# PCI-SIG ENGINEERING CHANGE NOTICE

<b>TITLE:</b>	Trusted Configuration Space for PCI Express
<b>DATE:</b>	March 23, 2005, Updated 1 July 2005
<b>AFFECTED DOCUMENT:</b>	PCI Express Base Specification, Rev. 1.1
<b>SPONSOR:</b>	Microsoft Corporation, Intel Corporation

**Figure 2-16: Request Header Format for Configuration and Trusted Configuration Transactions**

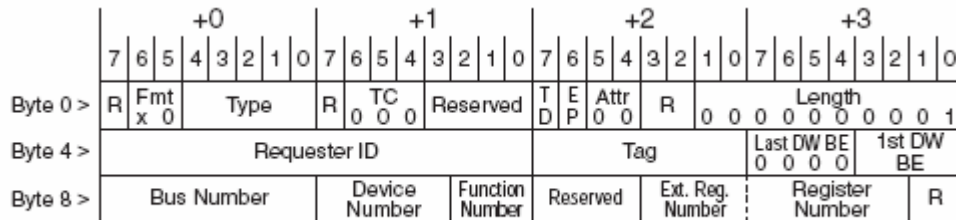
For Configuration and Trusted Configuration Requests, the following rules apply:

- ❑ Configuration and Trusted Configuration Requests route by ID, and use a 3 DW header
- ❑ In addition to the header fields included in all Memory, I/O, ~~and~~ Configuration and Trusted Configuration Requests and the ID routing fields, Configuration and Trusted Configuration Requests contain the following additional fields (see Figure 2-16)

- Register Number[5:0]
- Extended Register Number[3:0]

❑ Configuration and Trusted Configuration Requests have the following restrictions:

- TC[2:0] must be 000b
- Attr[1:0] must be 00b
- Length[9:0] must be 00 0000 0001b
- Last DW BE[3:0] must be 0000b

**Figure 7-87: Configuration Access Correlation Capability**

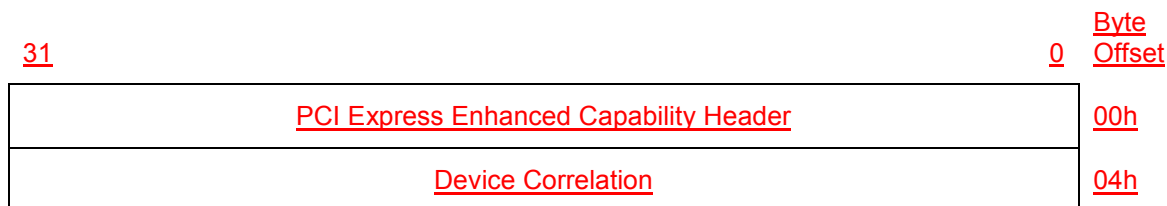
540 The PCI Express Configuration Access Correlation (CAC) capability is an optional extended capability that must be implemented by any PCI Express device that provides a Trusted Configuration Space. The CAC is used by software running within the TSE to identify Trusted Devices. Contained within the CAC is a read-only 32-bit value that is used by software running within the TSE to validate that Standard Configuration Space accesses performed via ECAM are targeting the same device as Trusted Configuration Space accesses performed via the corresponding TCAM. Figure 7-87 details allocation of register fields in the PCI Express Capability structure.

545 PCI Express devices that implement this capability must also implement the corresponding CAC Trusted Capability in Trusted Configuration Space (see Section 7.21.2). Both capabilities must access the same register for the Device Correlation—it is by this means that correlation is verified by software running in the TSE.

Figure 7-90: Trusted Configuration Space Header

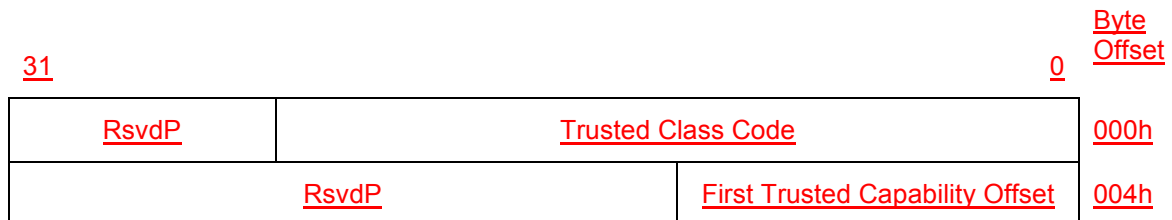
570 Figure 7-90 details allocation for register fields of the Trusted Configuration Space header for PCI Express Trusted Devices; Table 7-77 provides the respective bit definitions. The Trusted Configuration Space header identifies the device class to software running in the Trusted Software Environment, and it points to the first Trusted Capability structure.

Figure 7-91: Configuration Access Correlation Trusted Capability

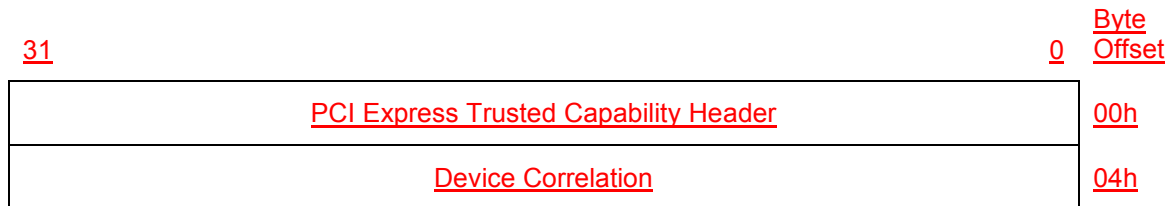
Figure 7-91 shows the PCI Express Configuration Access Correlation Trusted Capability structure.

**Figure 7-94: PCI Express VSTC Structure**

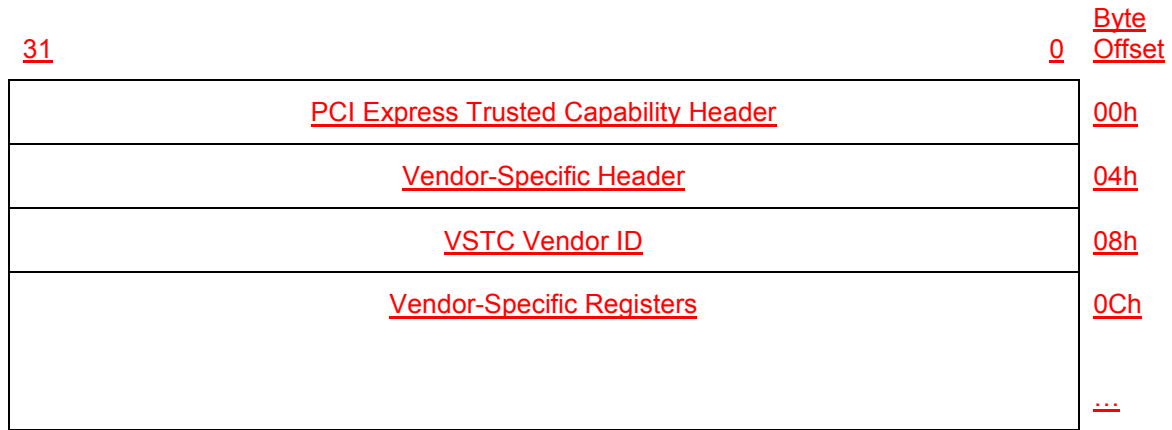
625 The VSTC in Trusted Configuration Space serves a similar purpose to that of the Vendor-Specific Extended Capability (VSEC) in Standard Configuration Space, as described in Section 7.18. The VSTC differs from the VSEC in that PCI Express functions are permitted to supply (public) VSTCs defined by vendors other than the device’s vendor (as identified by the Vendor ID register located at byte offset 00h in PCI-compatible Configuration Space).

630 Figure 7-94 details allocation of register fields in the VSTC structure. The structure of the PCI Express Trusted Capability Header, the Vendor-Specific Header, and the VSTC Vendor ID is architected by this specification. The structure and definition of the Vendor-Specific Registers area is determined by the vendor indicated in the VSTC Vendor ID register located at offset 08h within the VSTC structure.

700  
**Figure X-1: Gating TCS Access Via TPM**

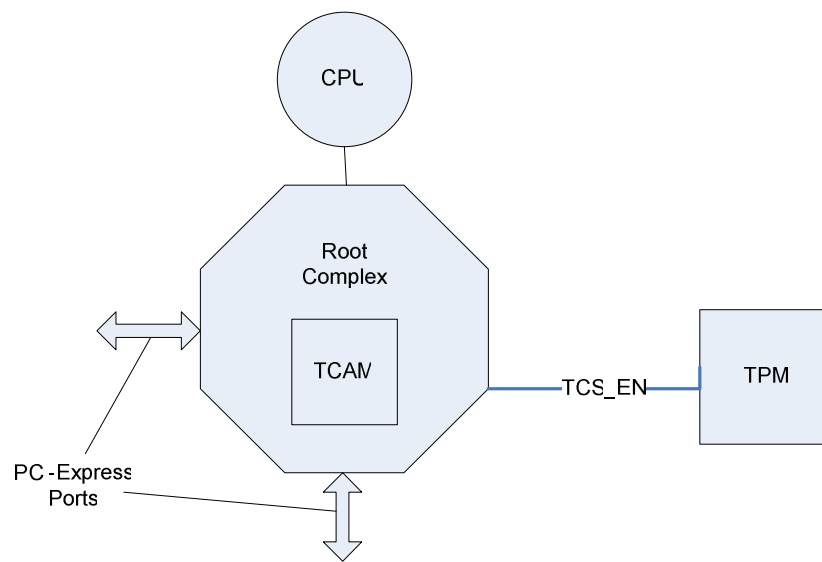
The system board for our example implementation would connect TPM GPIO pin 0 to the TCS\_EN# pin of the root complex as illustrated in Figure X-1 below.
